AGENDA
Cascade Charter Township Planning Commission
Monday, August 15, 2022
7:00 pm
2870 Jacksmith Ave

STAFF REPORT: Case # 22-3729
REPORT DATE: August 10, 2022
PREPARED FOR: Cascade Charter Township Planning Commission
MEETING DATE: August 15, 2022
PREPARED BY: Brian Hilbrands, Planning Director

REQUESTED ACTION: Site Plan Review for a new two-story, 10,000 sq ft building and parking lot.

**Kuiper Kraemer Building, 6660 Old 28th Street
Site Plan Review**

LANDSCAPE PLAN
 FOR
 6660 OLD 28TH STREET
 CASCADE TOWNSHIP, KENT COUNTY, MICHIGAN

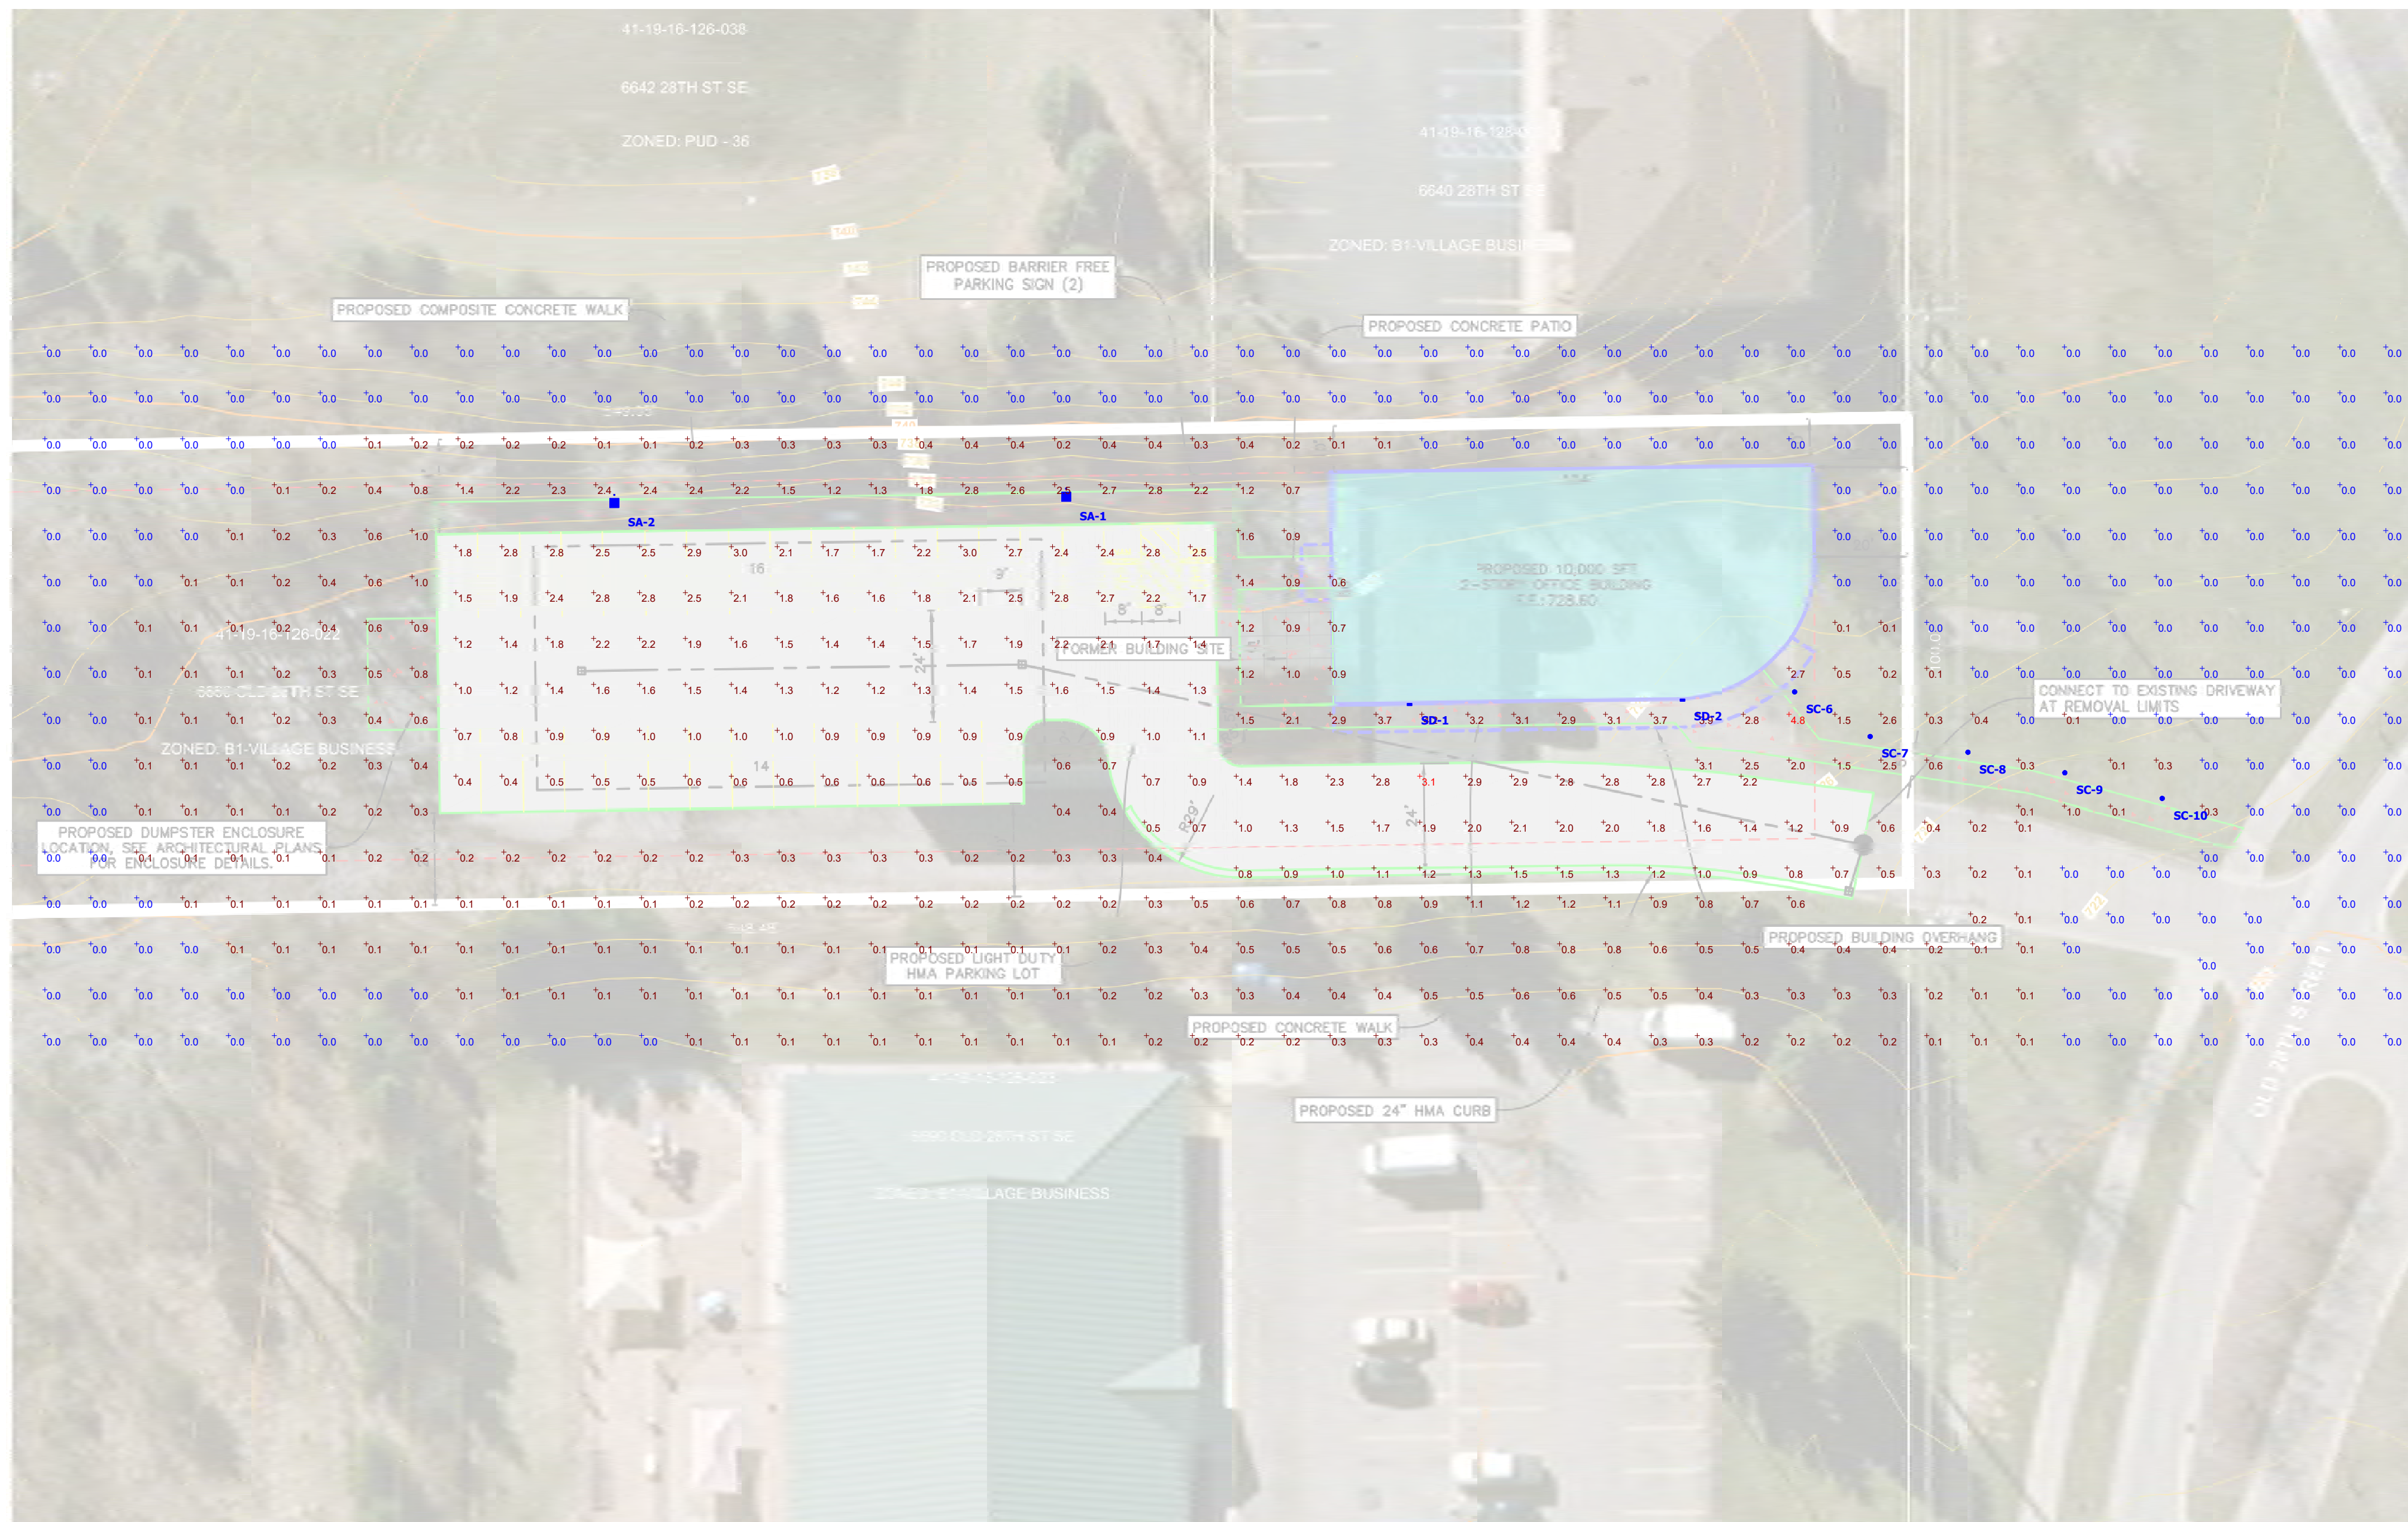
10. A comprehensive landscape plan was submitted that includes new plantings around the building and parking lot, while maintaining a large number of existing trees on the southern end of the property. A landscape bond in the amount of no less than \$19,000 should be submitted.

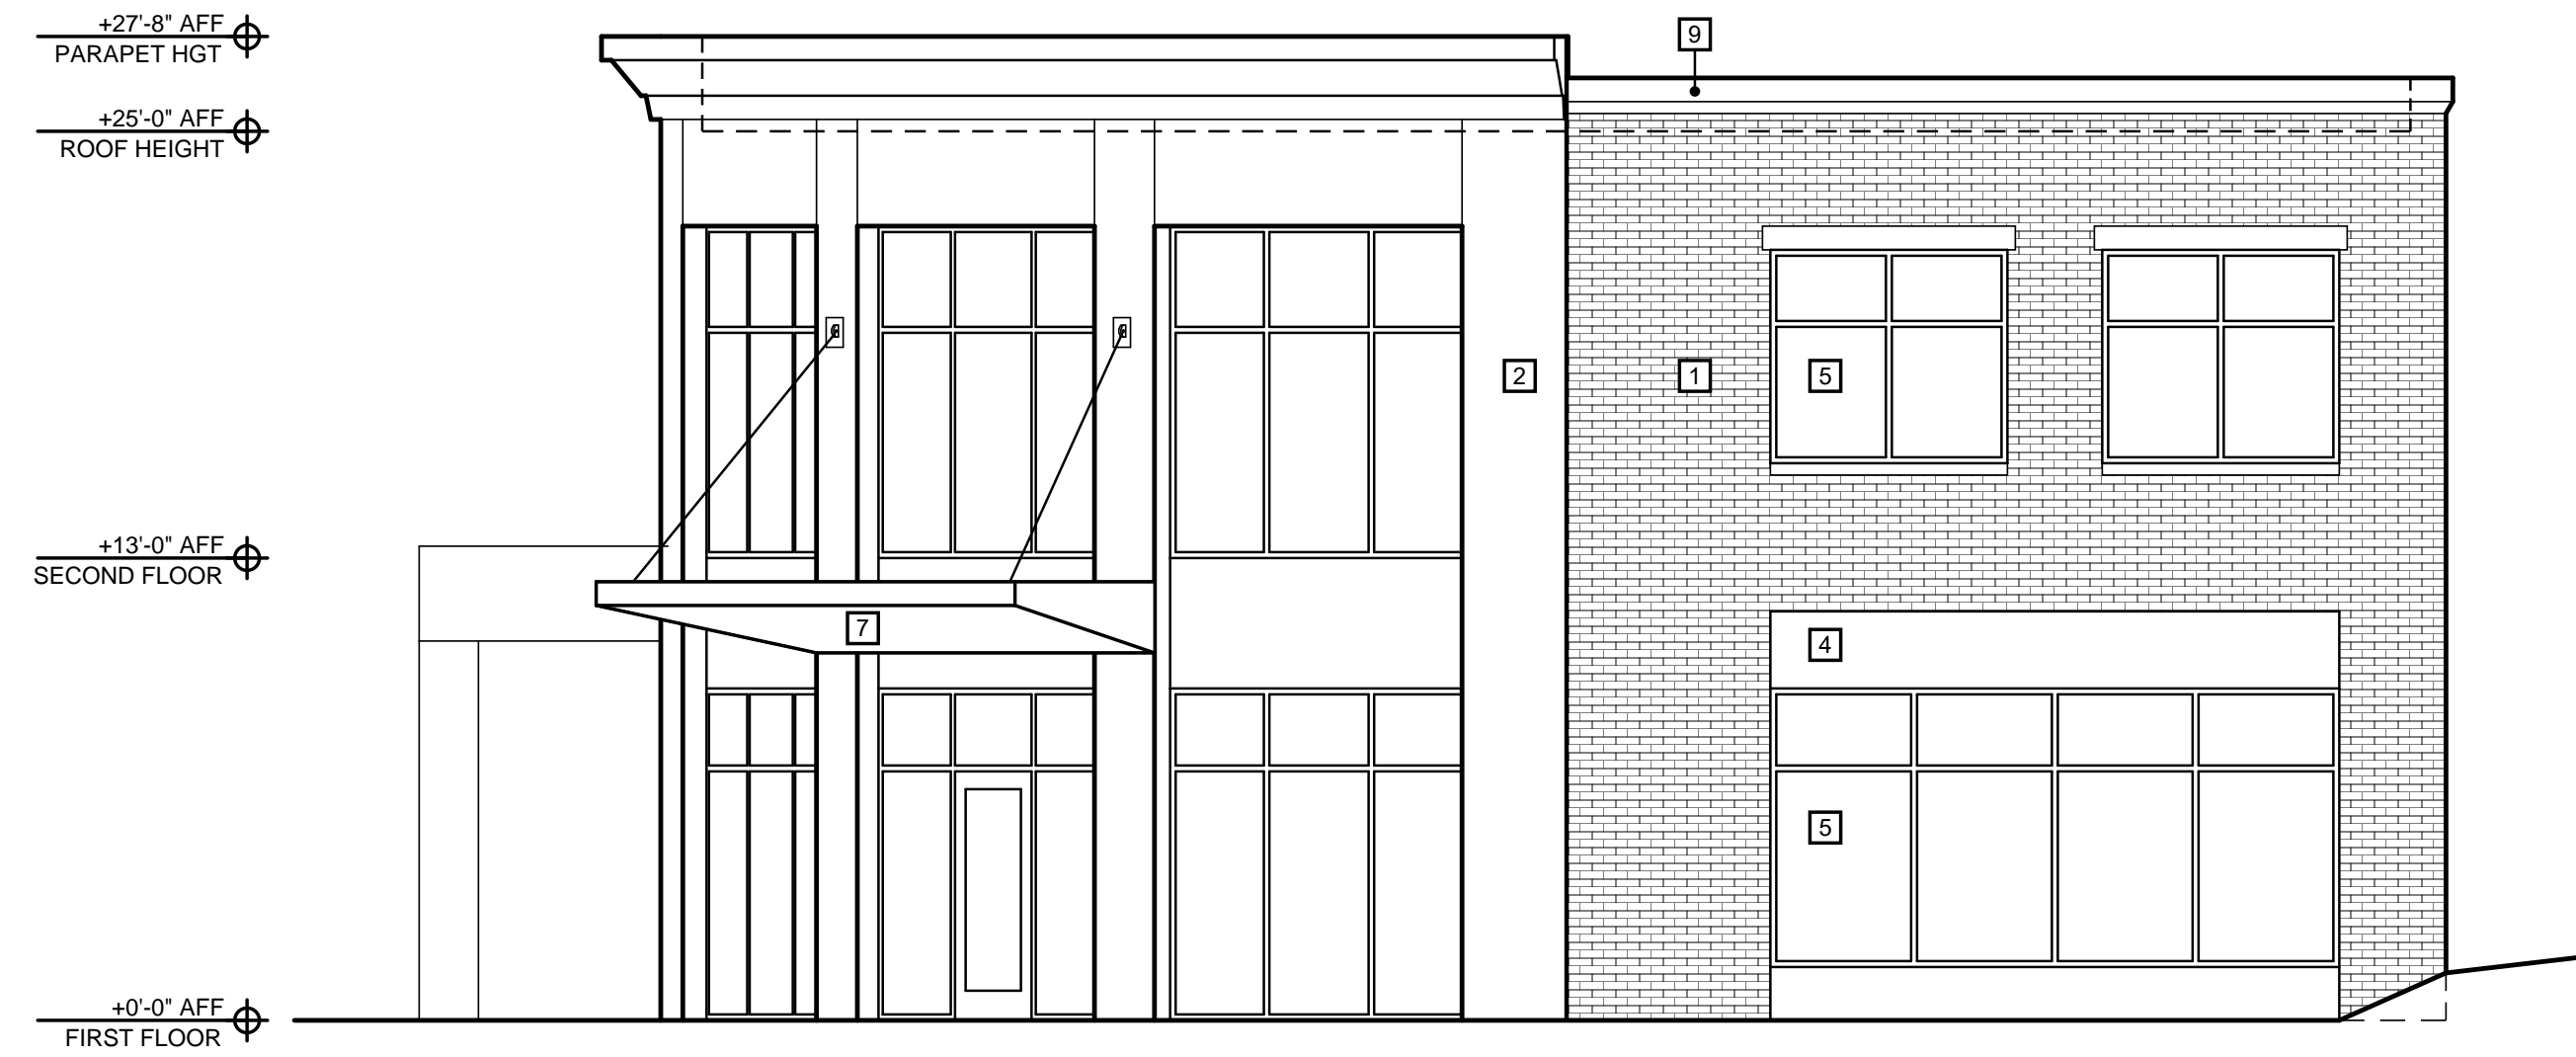
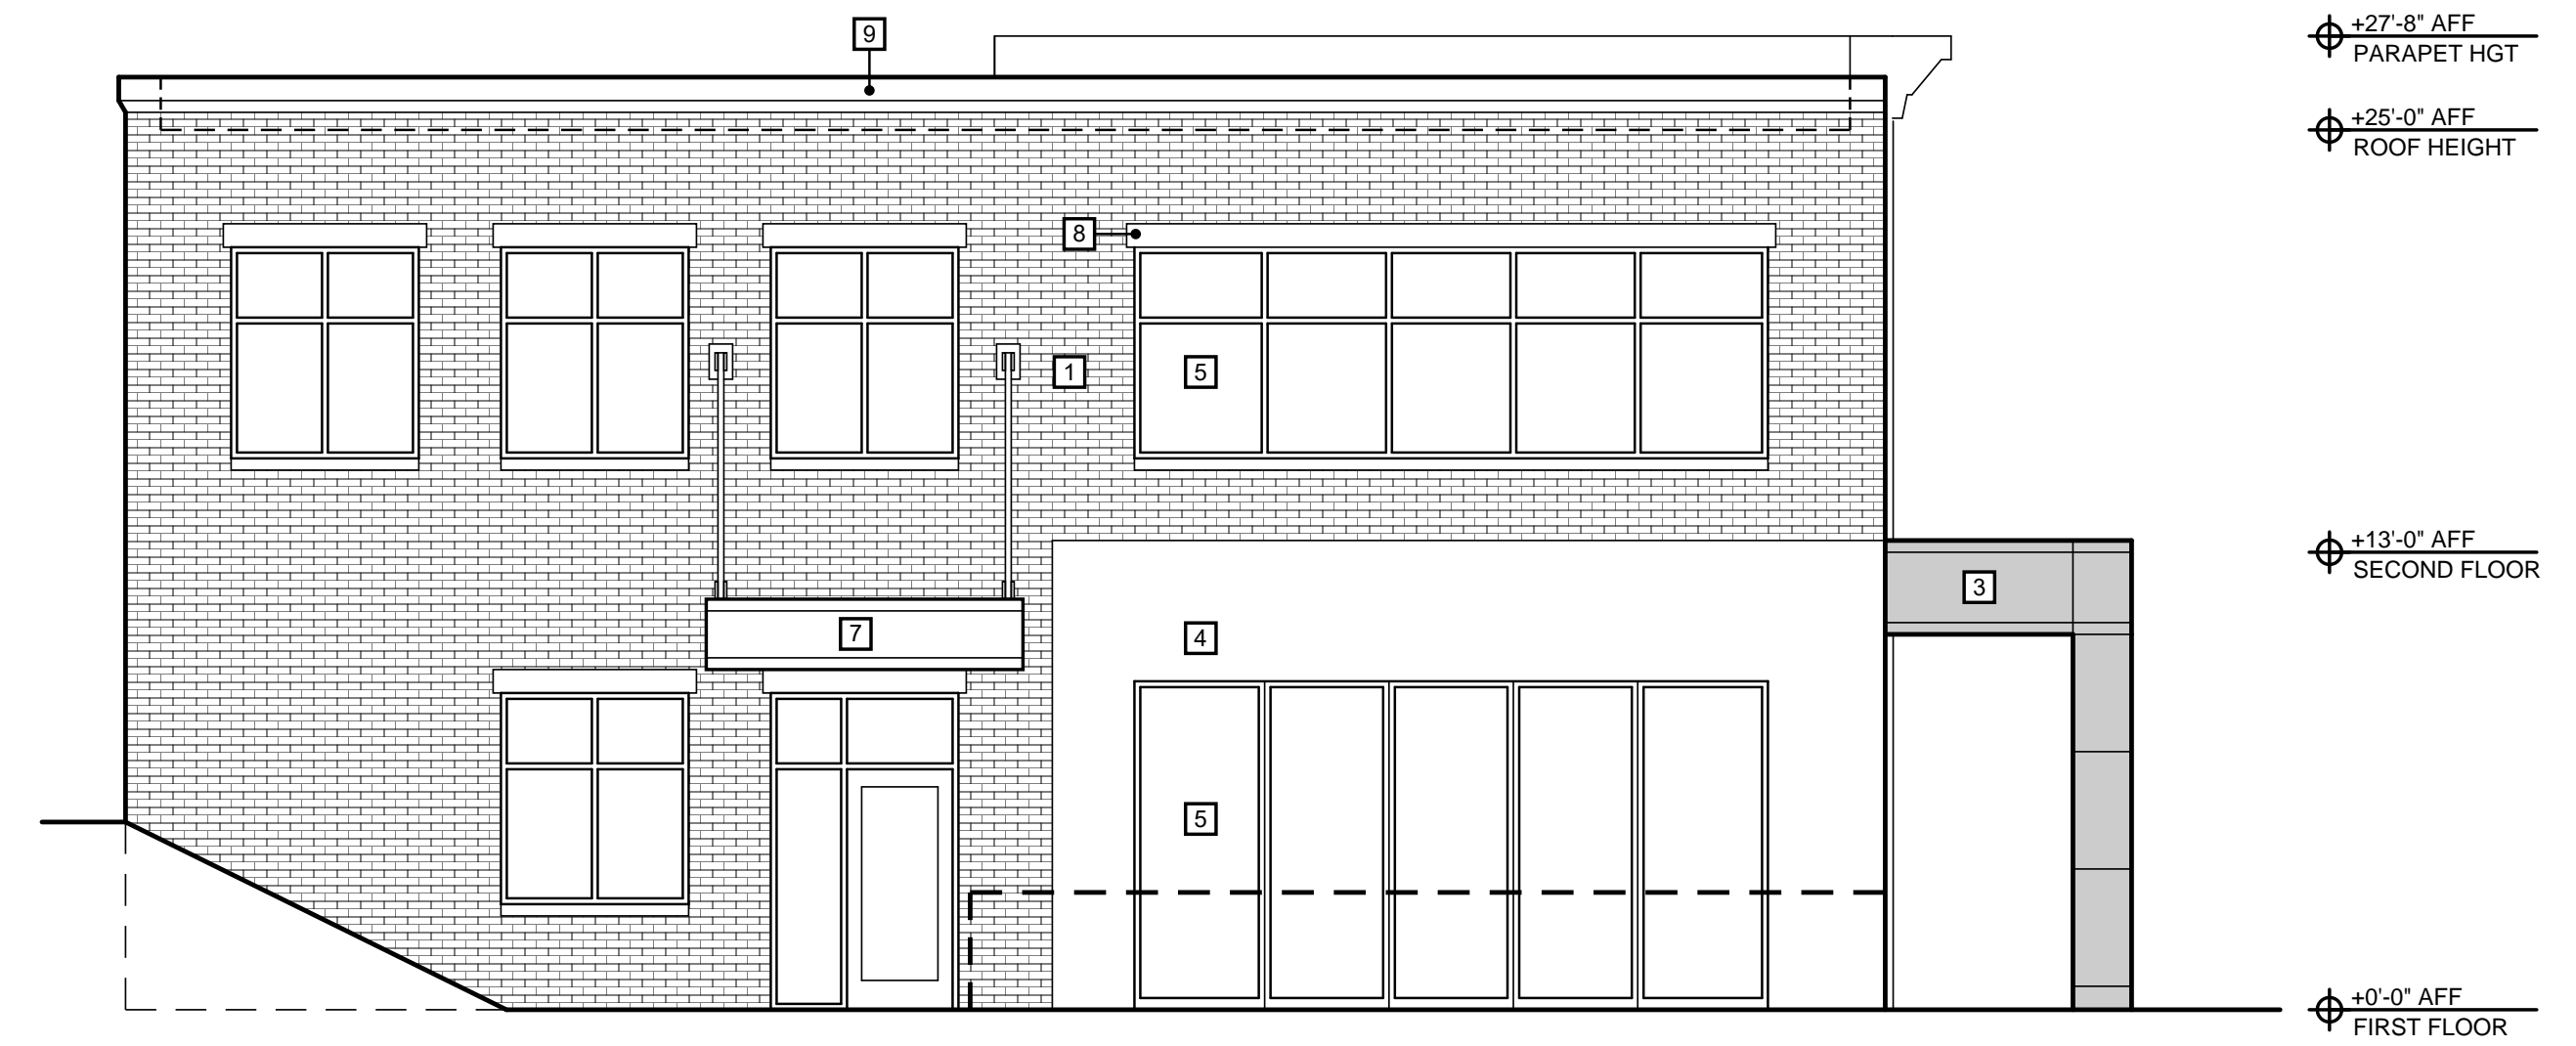
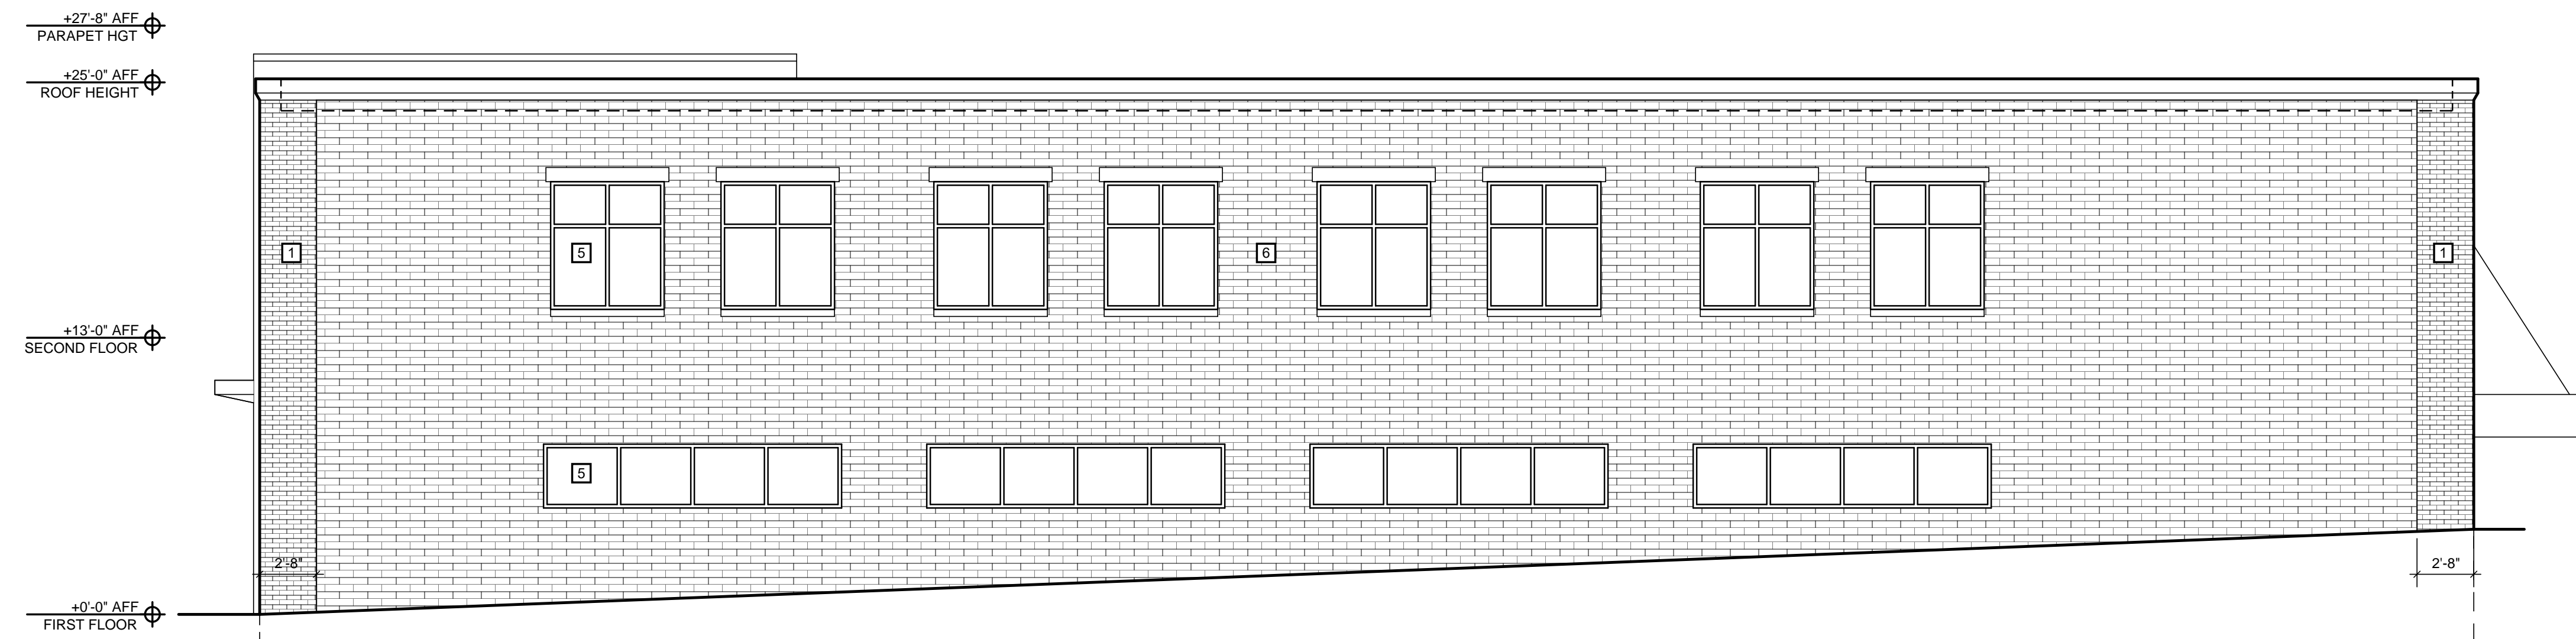
4. However, I would like to call attention specifically to design standards 6 and 11 of Section 8.08. Standard 6 requires that all sides of the building must use materials consistent with the front, and that lesser quality materials may not be used. Three sides of the building are shown to have brick veneer, while the rear is shown to have masonry veneer. Masonry is a permitted material, but it is not the same as what is on the front. The Planning Commission should consider if they believe this meets the design standard.

5. Design standard 11 allows for flat roofs to be used, but only if a stepped parapet façade is proposed. The proposed design does show a parapet with one step. The Planning Commission should consider if they believe this meets the design standard.
